Ref: FCC Class II Permissive change for FCC ID: 2BO5E-VENUS

Applicant: Luckin Food Technology (Shanghai) Co LTD

This is to request a Class II Permissive change for FCC ID: 2BO5E-VENUS originally granted on 06/09/2025 (date).

Detail of changes as below:
Main control board (functional)

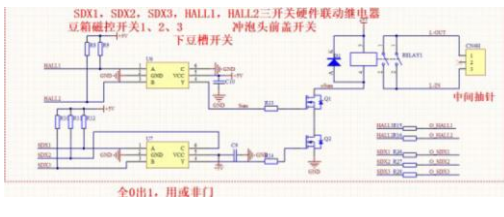
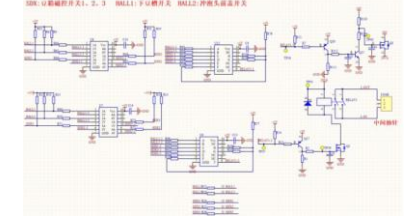
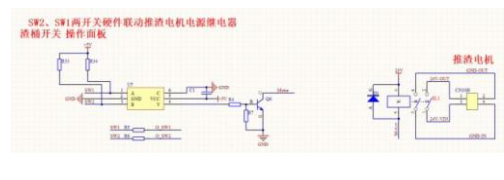
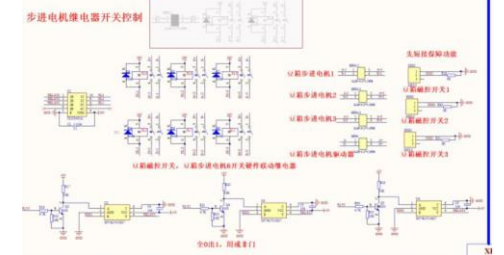
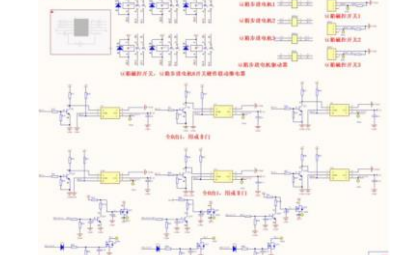
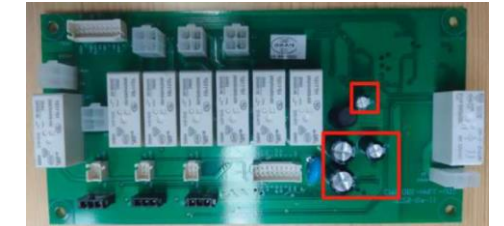
Original	New	Differences
/		For the water level probe detection problem, remove the C108 patch capacitor. Troubleshooting water shortage problems.
		R451,R427,R435,R465 chip resistance change. Improve the accuracy of AD detection.
		Modify 24V power supply and ground loop. Mainly used to detect whether the brushless motor is blocked; and form a hardware linkage with the Hall board.
		All electrolytic capacitors are replaced by solid electrolytic capacitors. Reduce the equivalent series resistance and improve the service life.
		L2,L3,L4,L8,L9 to shield inductance Improve EMC, increase the heat dissipation effect, increase the current flow capacity.
		RLL1,RLL2 Relay Change Manufacturer Changed from Sanyo to Omron Improve the working performance of the relay.

CN6,CN15,CN5,CN10 sockets are replaced by 5566 specifications for 5569 specifications.

The 5569 socket is more solid, and the cable is not easy to loosen.

J2,DGB1 Burn Pin Changed from Pin to Socket.

It is convenient for software engineers to debug programs.

Hall board (functional)

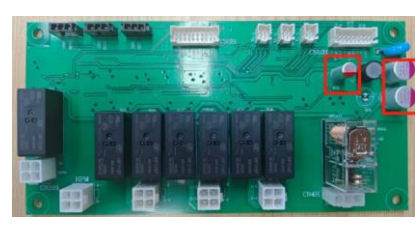
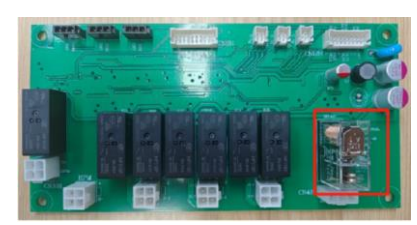
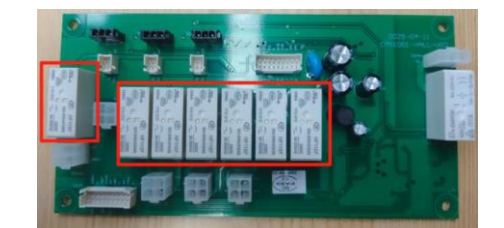
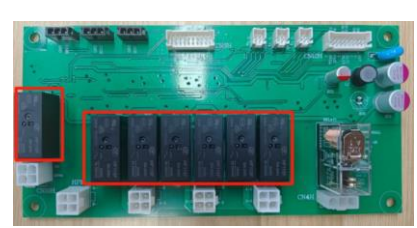
Original	New	Differences
		Added U9 and U13 protection circuits to meet the requirements of safety regulations
		Add U8 protection circuit to meet the requirements of safety regulations
		Added protection circuits U10, U11 and U12 to meet safety requirements
		All electrolytic capacitors are replaced by solid electrolytic capacitors. Reduce the equivalent series resistance and improve the service life
		RELAY1 Relay Change Manufacturer Changed from Sanyou to Omron Improve the working performance of the relay
		RL1,3,4,5,6,7,8 relay change model from HF115-024-2HS4A to HF115-024-2HS4
		CN10H;HPM;HPM1;HPM2;HPM3 socket is changed from 5566 specification to 5569 specification. The 5569 socket is more solid, and the cable is not easy to loosen.
